Subject: AP1000 COL Standard Technical Report Submittal of APP-GW-GLR-005, Revision 1 (TR 9)

“Containment Vessel Design Adjacent to Large Penetrations”

Technical Report 9

# AP1000 Standard Combined License Technical Report

**Figure 3.8.2-7**  
Finite Element Model for Large Penetration Local Analyses

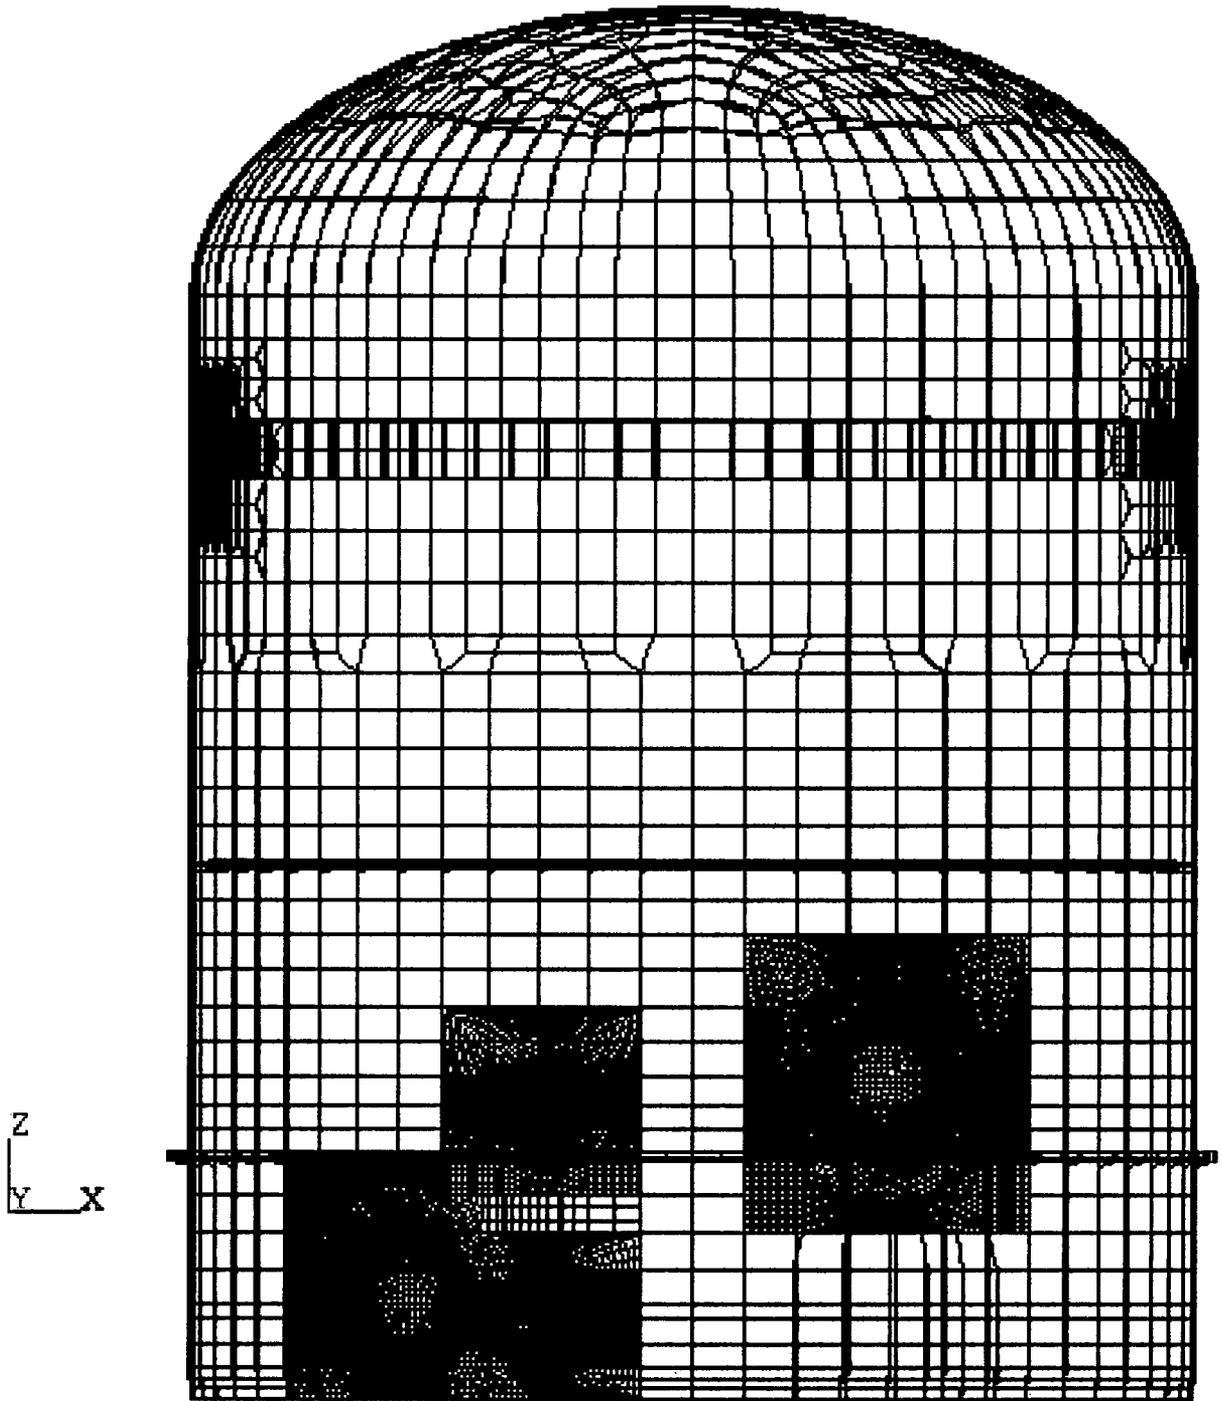
1. Service limit levels are per ASME-NE.
2. Where any load reduces the effects of other loads, that load is to be taken as zero, unless it can be demonstrated that the load is always present or occurs simultaneously with the other loads.
3. **Reduced pressure of 0.9 psid at one hour in loss of all AC transient in cold weather**
4. **Temperature of vessel is 70F**
5. **Temperature distribution for loss of all AC in cold weather**  
Replace Figure 3.8.2-7 by the figure below

Static analyses are performed using the finite element model shown in Figure 3.8.2-7 for internal pressure, dead load (including the polar crane in the parked position), thermal loads and seismic loads. The global seismic loads are applied as equivalent static accelerations using the maximum accelerations from the nuclear island stick model given in DCD Table 3.7.2-6. The amplified local responses are included separately for each of the four penetrations. Local seismic axial and rotational accelerations about both horizontal and vertical axes are applied based on the maximum amplified response determined from a time history analysis on a less refined dynamic model with seismic time histories at elevation 100'.

**Figure 3.8.2-4 (Sheet 2 of 6)**  
**Containment Penetrations Startup Feedwater**

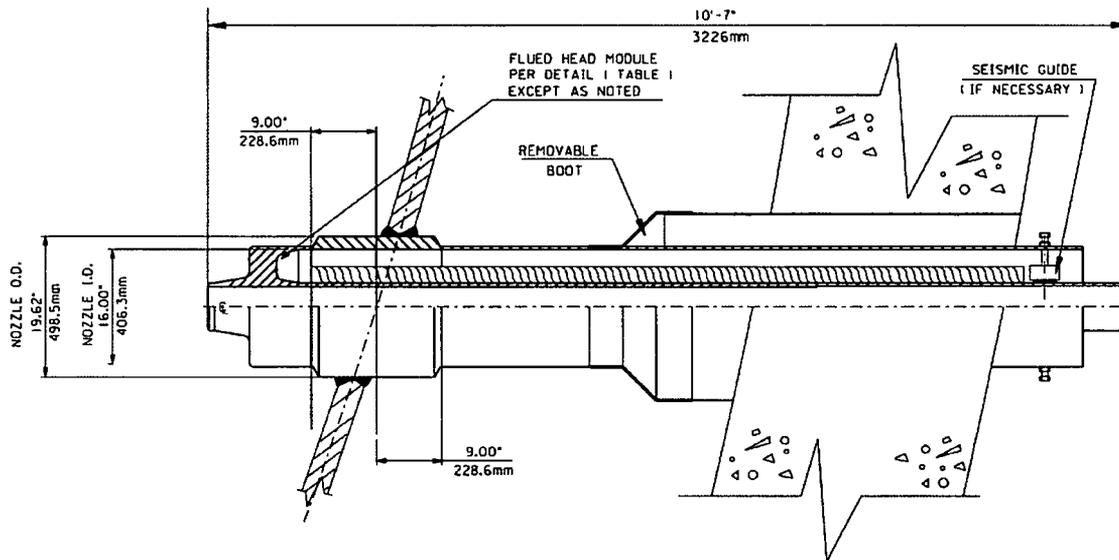
Revise sheets 2, 3, 4 and 6 of Figure 3.8.2-4 as shown on the following pages to reflect detail design of the penetration reinforcement.

Figure 3.8.2-4 (Sheet 4 of 6)  
Containment Penetrations

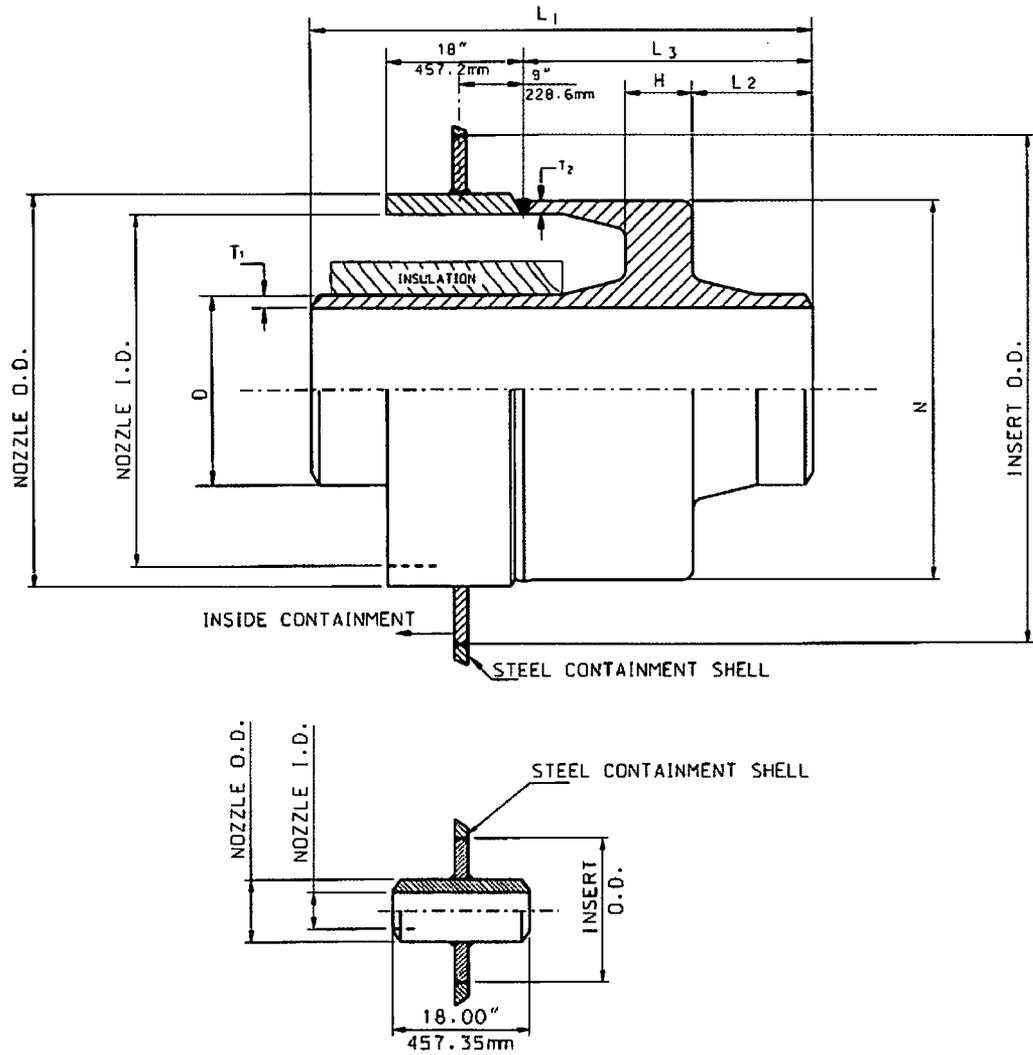
Revise classification in Table 3.2.3 as shown below from MC to Class 2 for penetrations where the process pipe penetrates directly the containment vessel without the use of a flued head (see typical detail on lower half of Figure 3.8.2-4, sheet 4 of 6). In this case the sleeve is a boundary of the process fluid and is required by the ASME Code to be Class 2.
